AC POWER SUPPLY CHANGE

Special edition of the bulletin to announce a part change.

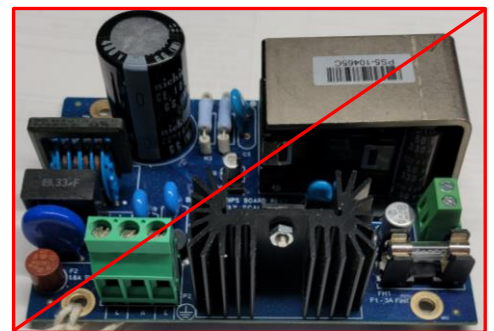
The Belt-Way AC Power Supply has been updated. The new part occupies the same space in the enclosure. However, it mounts to standoffs on the underside of the the back panel, not to the base of the enclosure.

Replacement parts will ship attached to a new back panel for compatibility. Limited supply of the original part will remain available until stock is depleted.

SPECIFICATION	NEW PART	OLD PART
AC Input Voltage	85-264VAC, 47~63 Hz	90-265VAC, 50~60 Hz
AC Input Current	1.4A/115V, 0.85A/230V	1.0A/115VAC
DC Output	24V, 3.2A	24V, 2.25A
Rated Power	75W	54W
Operating Temp	-30°C to 70°C	-20°C to 45°C
Certifications	See Below*	CE
